HILLIARD PLANNING AND ZONING BOARD MEETING

SUBJECT: Planning and Zoning Board approval of Site Plan Application No. 20240131. Parcel #16-3N-24-0000-0024-0070. Applicant: Karen Brantley, Florida Infrastructure.

Site Plan Application 20240131 Florida Infs.
Review Report

RE: Determination of Completeness and Site Plan Review
Florida Infrastructure Truck Shop
Town of Hilliard, Florida
Mittauer & Associates, Inc. Project No. 9610-23-26

C2.0
 PROJECT NUMBER
 2023-1216

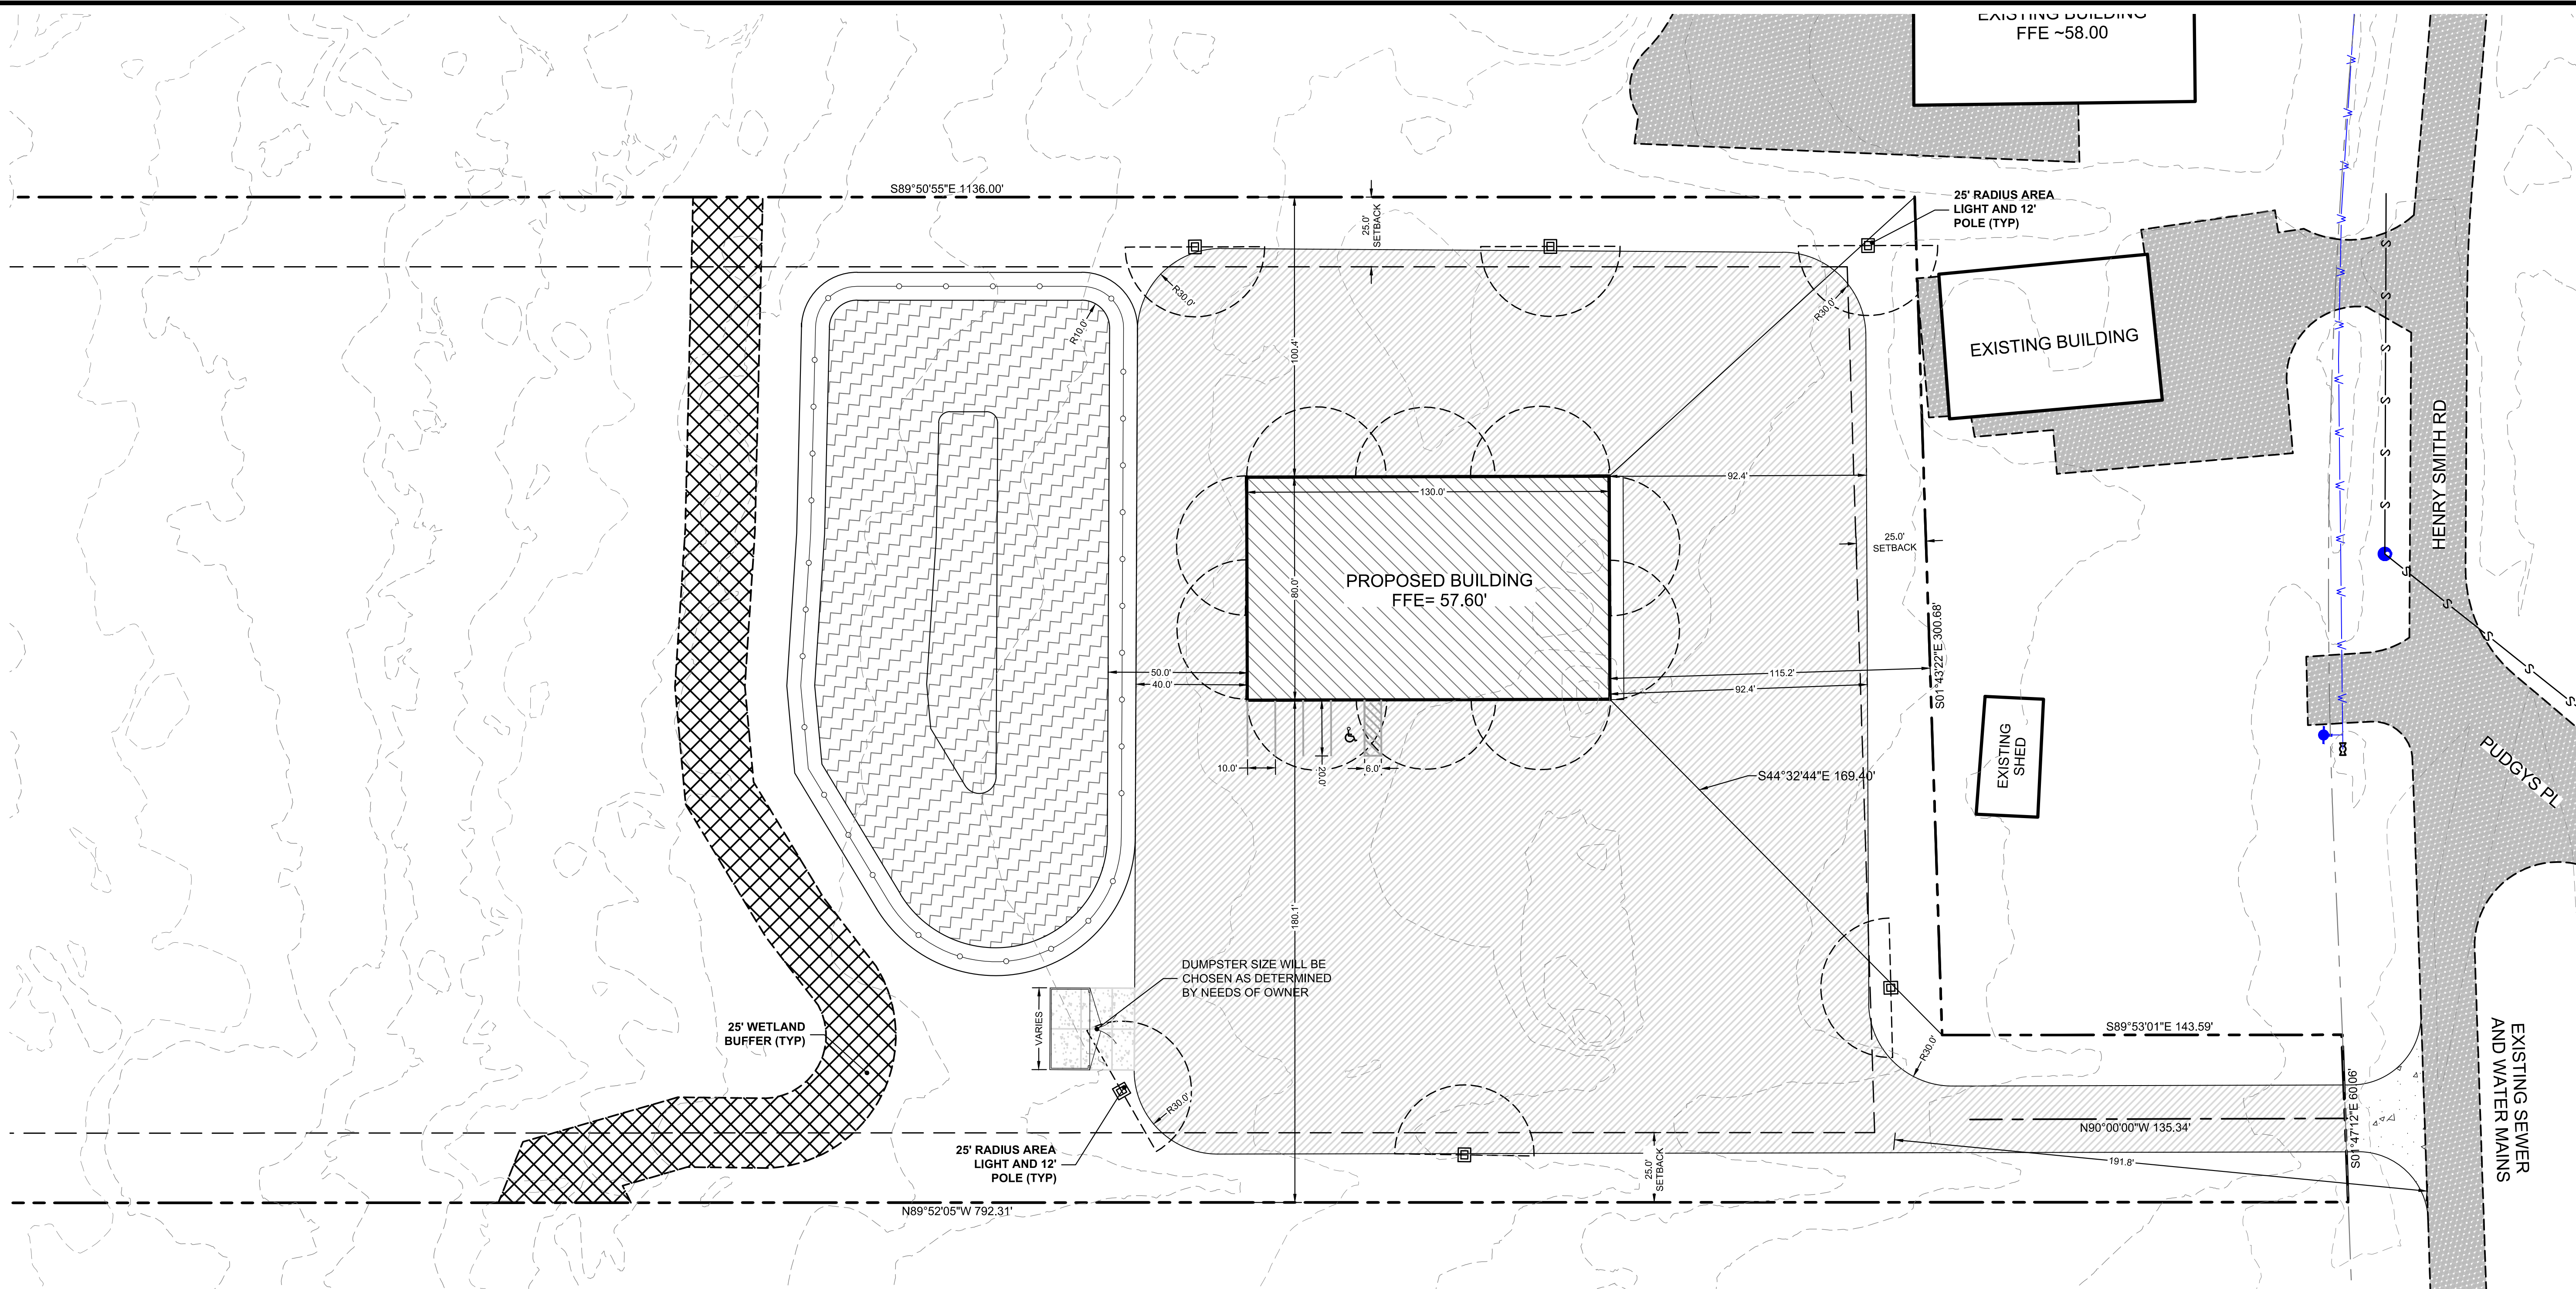
SHEET C2.0 - EXISTING CONDITIONS

1. No existing trees are shown. Confirm if any trees within the project limits and/or site property boundary will remain/be protected.
2. Existing sewer and water mains are identified within Henry Smith Road with no detail just beyond the proposed entrance. Per Town Utility Maps and via Public Works staff correspondence, existing sewer and water does not exist in this location, but rather further to the north at Pudgy's Place. Recommend coordinating with Town staff to survey / locate existing utilities to accurately verify and determine proposed connection points.

2. Existing sewer and water mains are identified within Henry Smith Road with no detail just beyond the proposed entrance. Per Town Utility Maps and via Public Works staff correspondence, existing sewer and water does not exist in this location, but rather further to the north at Pudgy's Place. Recommend coordinating with Town staff to survey / locate existing utilities to accurately verify and determine proposed connection points.

Town Staff provided approximate locations which are now reflected on the plans. Contractor to confirm/verify location prior to connecting to a sewer manhole or tapping water mains.

C3.0
 PROJECT NUMBER
 2023-1216

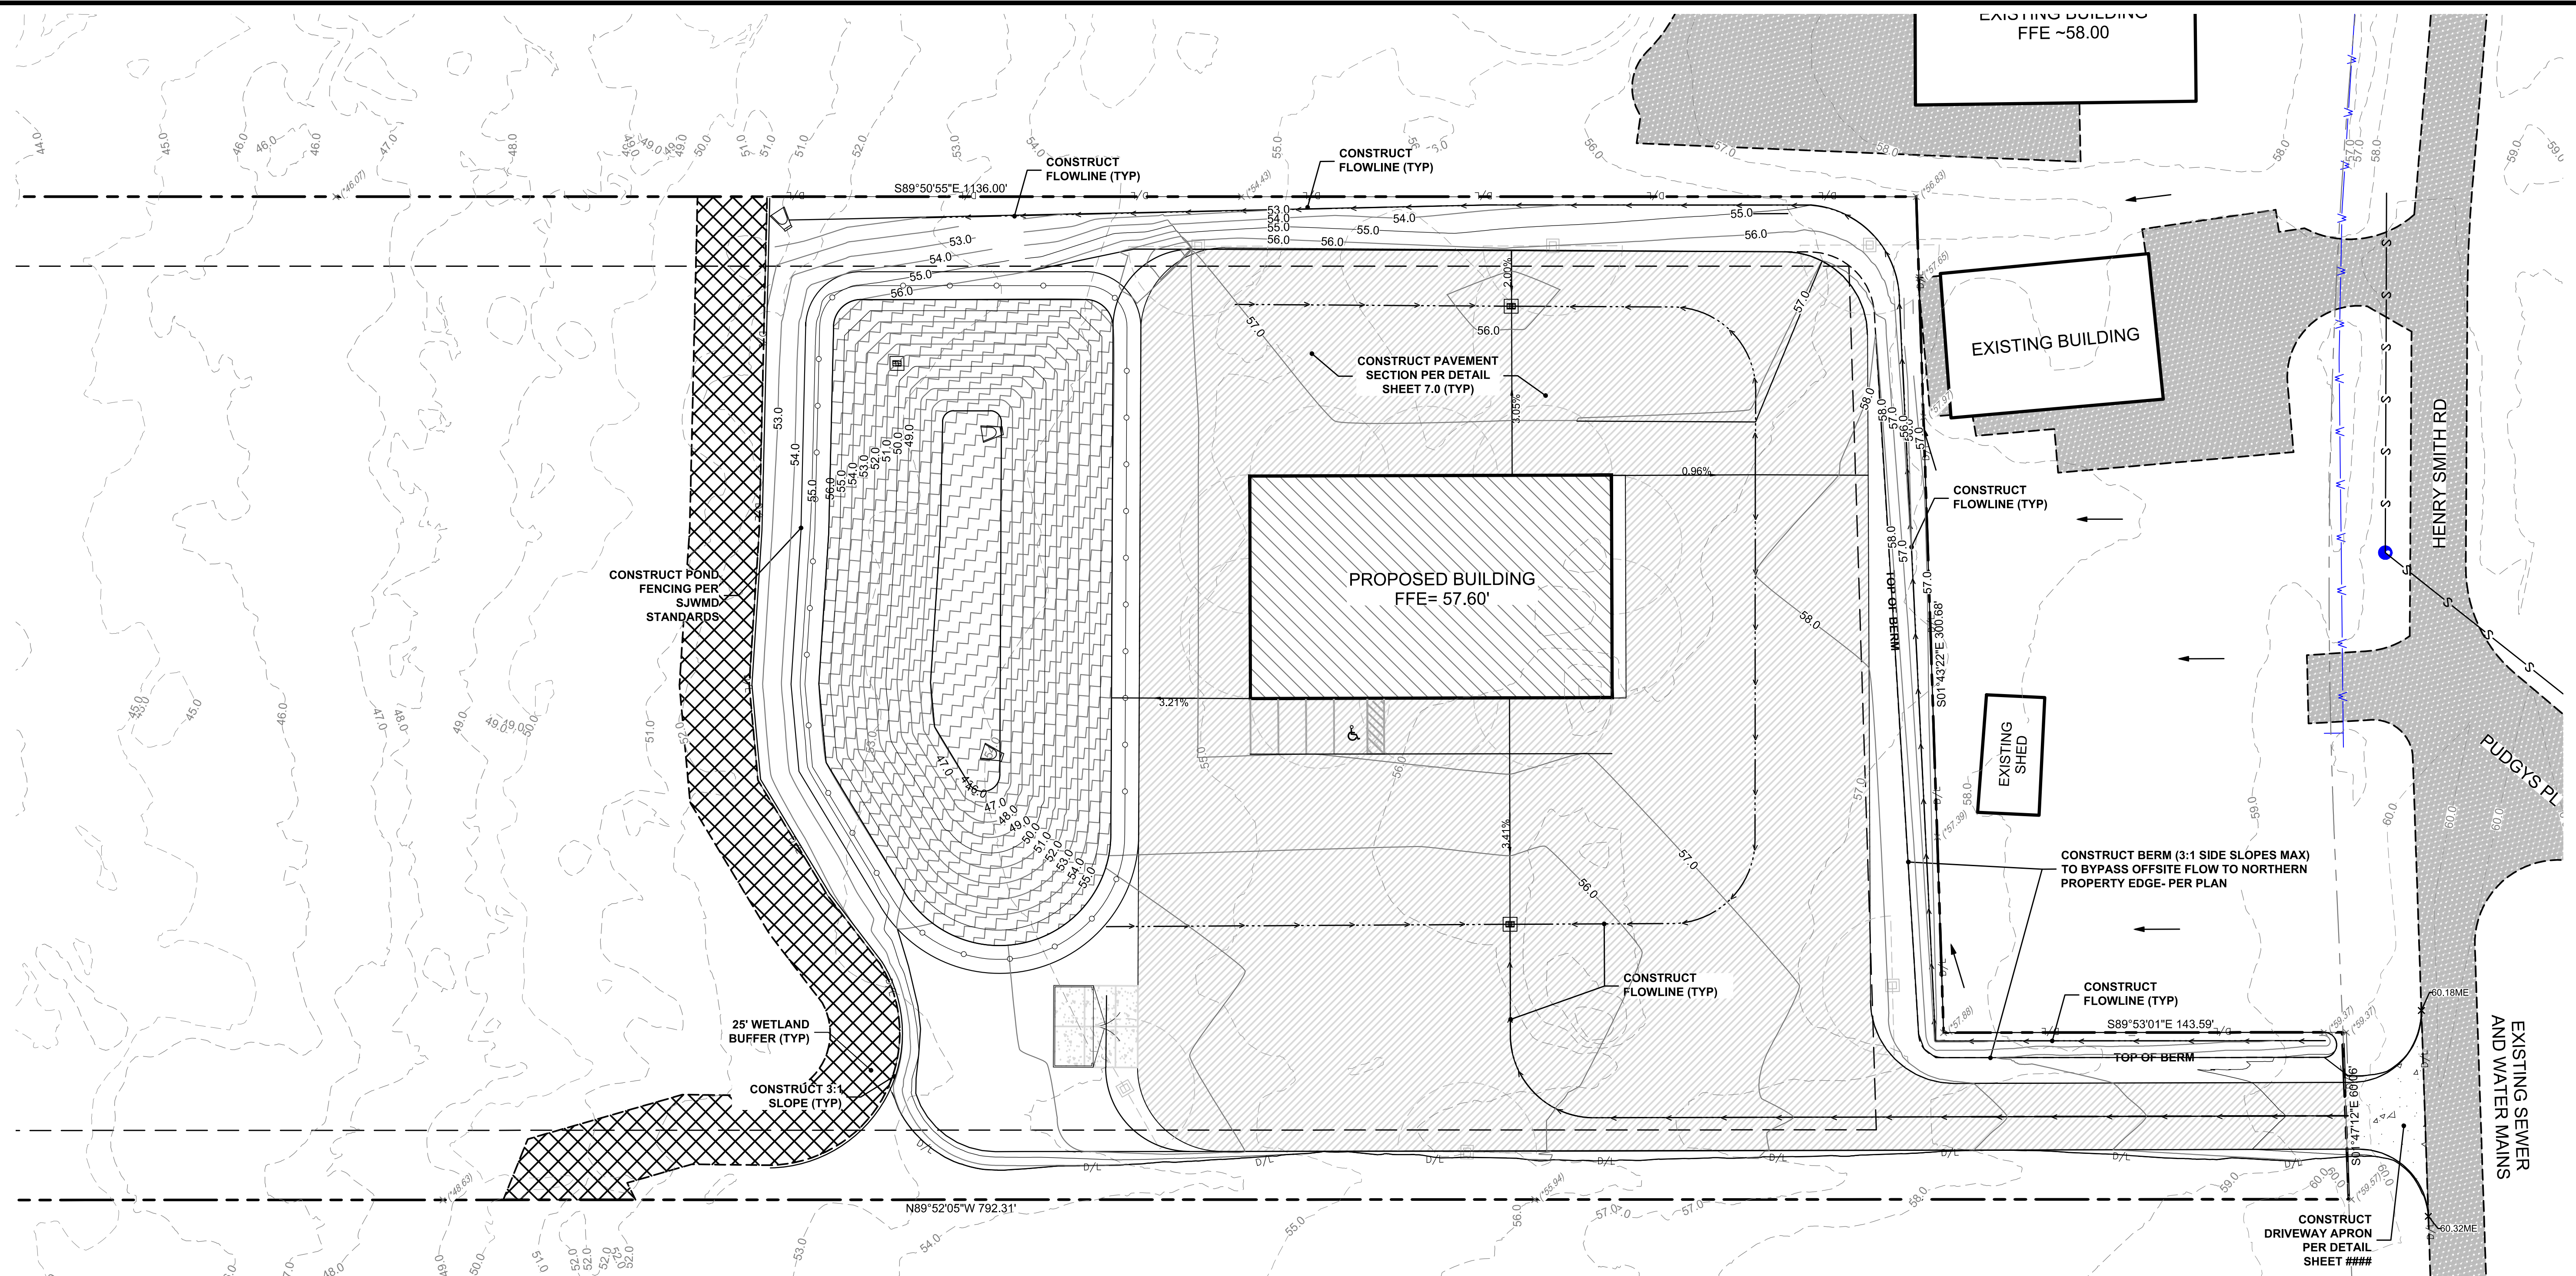
SHEET C3.0 - SITE PLAN

1. Data Summary Table indicates Nearest Fire Hydrant is proposed onsite. No Fire Hydrant appears on this Sheet or Sheet C6.0. Revise, as applicable.

2. Data Summary Table indicates Utilities will include Gravity Sewer Connection to Town's system, although an onsite pump station and force main (and presumably a force main connection) are proposed. Revise, as applicable.

1. Data Summary Table indicates Nearest Fire Hydrant is proposed onsite. No Fire Hydrant appears on this Sheet or Sheet C6.0. Revise, as applicable.

2. Data Summary Table indicates Utilities will include Gravity Sewer Connection to Town's system, although an onsite pump station and force main (and presumably a force main connection) are proposed. Revise, as applicable.

Data summary table has been revised to reflect fire hydrant ~125' N of entrance drive.

Data summary table has been revised to reflect pump station and force main connection.

C4.0
 PROJECT NUMBER
 2023-1216

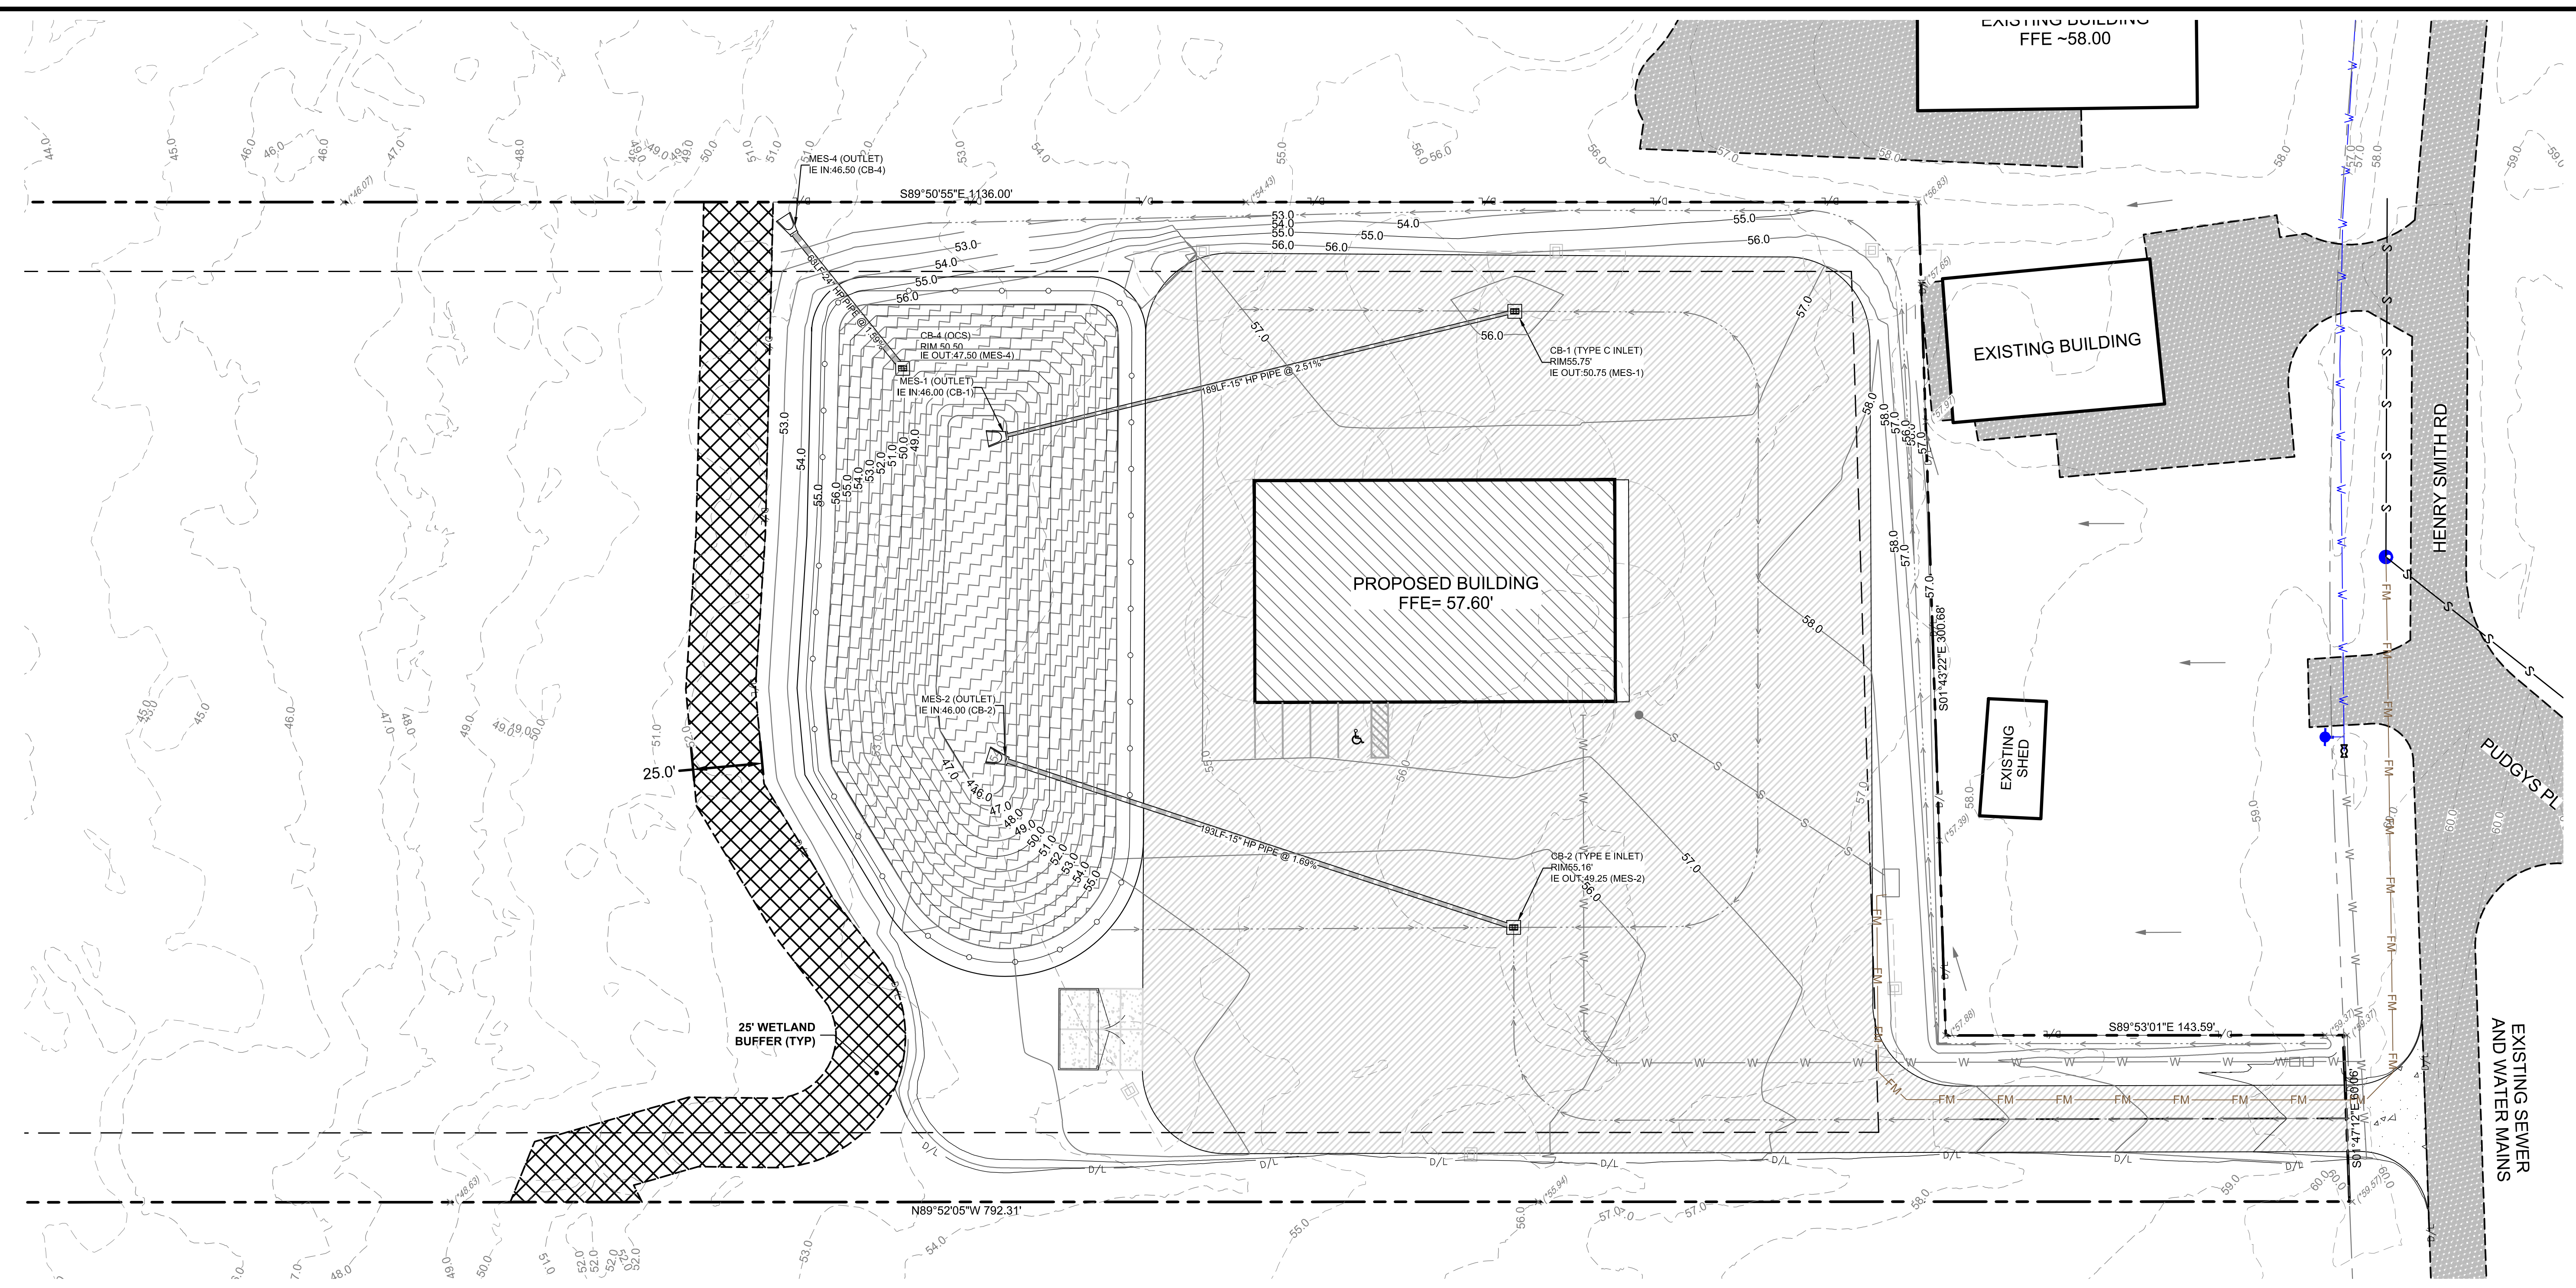
SHEET C4.0 - GRADING PLAN

1. Coordinate with the Town for driveway connection requirements at Henry Smith Road.
2. Recommend using a maximum slope of 4:1 throughout to minimize erosion.
3. Provide detail for the installation of the asphalt millings surface (compaction, etc.).

1. Coordinate with the Town for driveway connection requirements at Henry Smith Road.
Noted.
2. Recommend using a maximum slope of 4:1 throughout to minimize erosion.
Noted. Where possible, 4:1 will be observed but 3:1 stabilized with sod or erosion control matting is also acceptable.
3. Provide detail for the installation of the asphalt millings surface (compaction, etc.).
Millings was originally considered but revised plans only consider asphalt pavement.
